ADDENDUM 1 (PENDING DSA APPROVAL)

PROJECT: **Santa Ana College**
 Science Center

DATE: 8/23/2017

DSA File No.: 30-C2
DSA Applications No.: 04-115788
HGA Commission No.: 3584-001-00

1 FIRE SPRINKLER PLAN - LEVEL 01
 1/8" = 1'-0"

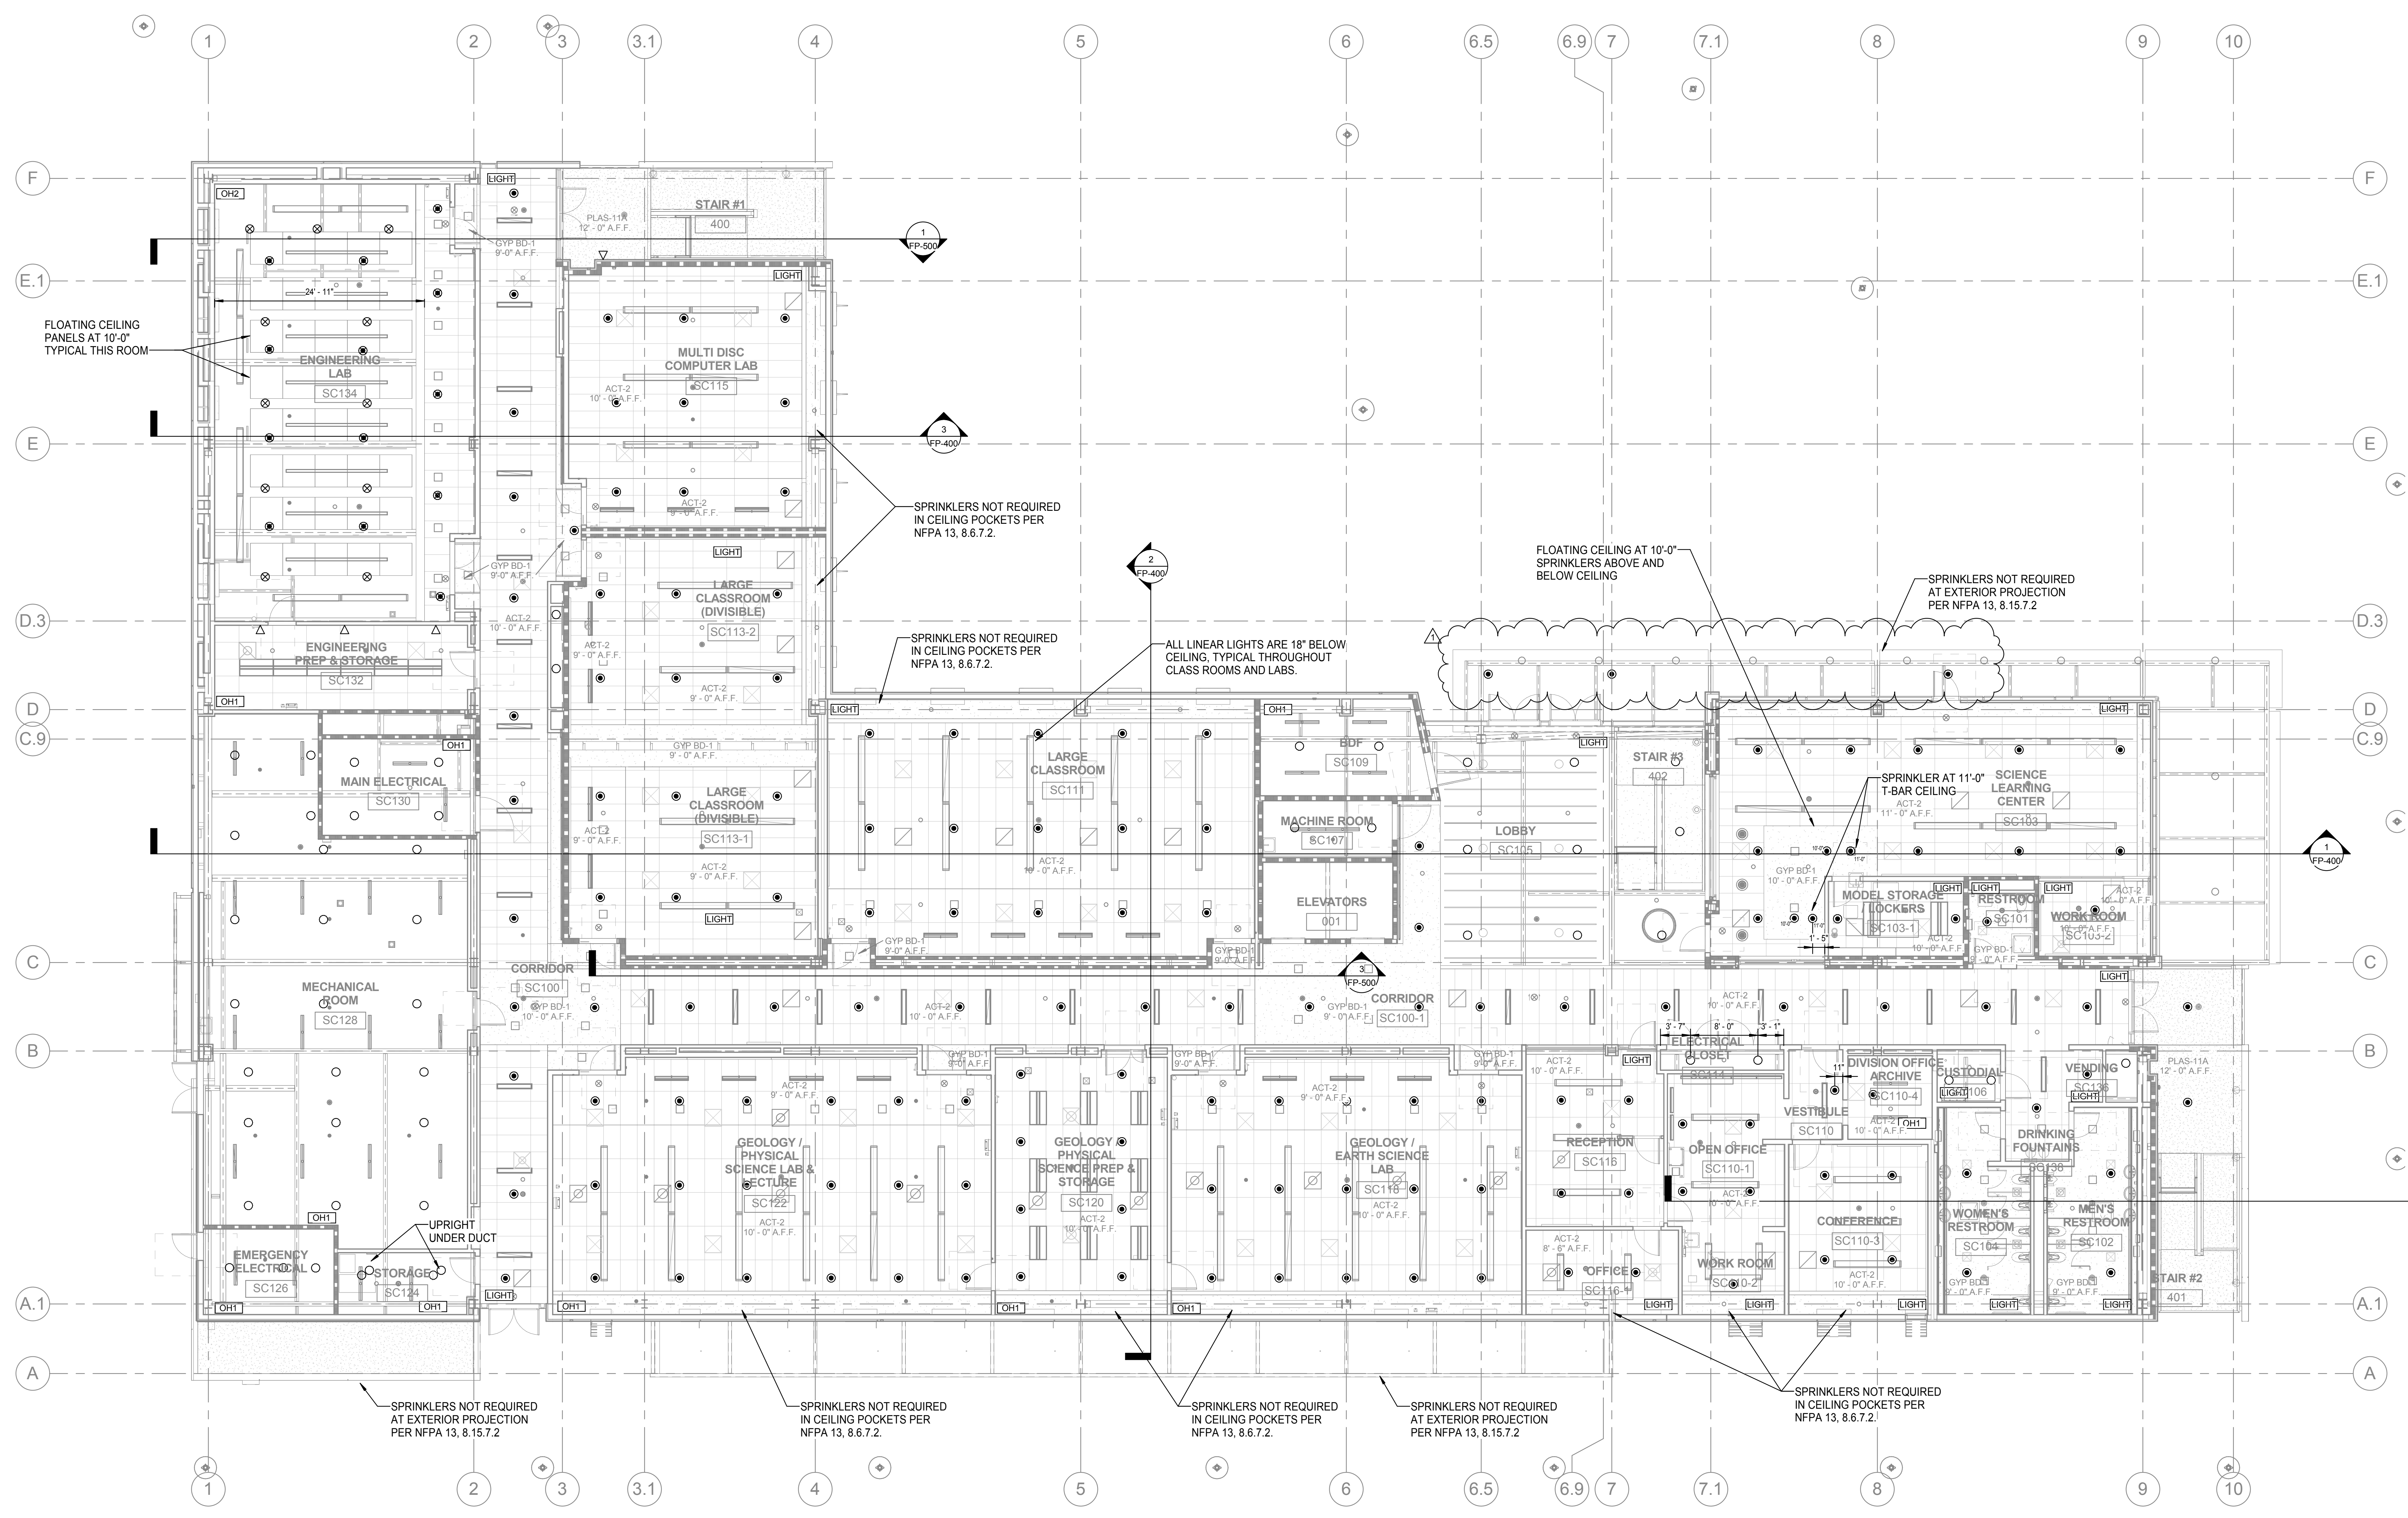
- North canopy reduced by 5'-0"
- Fire Sprinkler locations shifted south and pipes are reduced in length.
